Technical Service Bulletin

MODEL(S) AFFECTED:	T7 Rider Scrubber
SUBJECT:	Drive motor wires may need to be repositioned to avoid wire abrasion when making right and left hand turns. Inspect the wire harness for clearance and if necessary reposition the wires as described below.
PURPOSE:	To prevent the risk of drive motor failure.
NOTES:

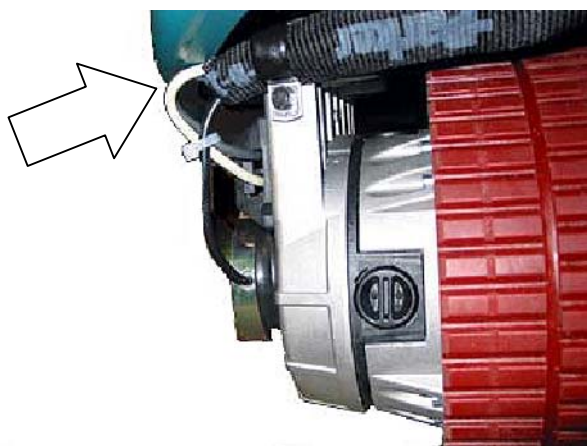
Abrasion point when making a left hand turn. Comes in contact with rotomold edge.

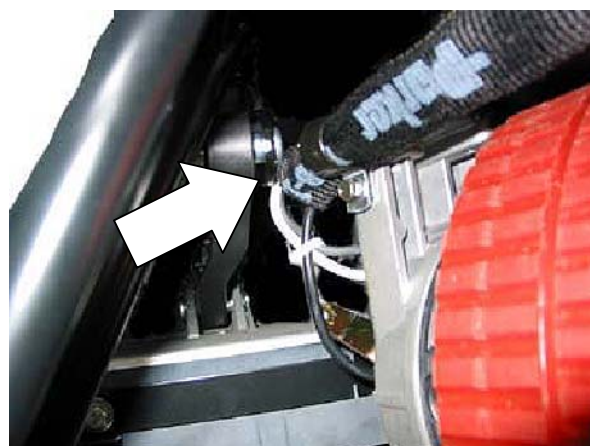
Abrasion point when making a right hand turn. Comes in contact with the scrub head pivot arm.

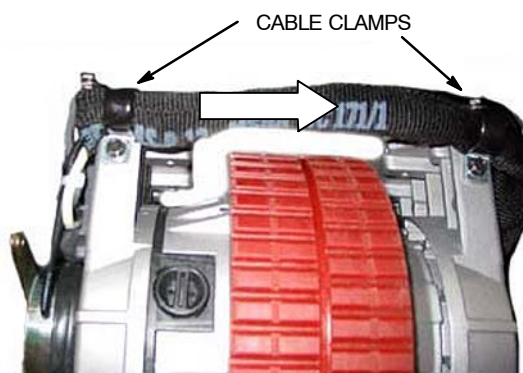
To reposition the wire harness to avoid abrasion:

1. Loosen the two cable clamps and move the wire harness away from the abrasion points. Re-secure clamps.

2. Secure the wires with two wire ties as shown below.
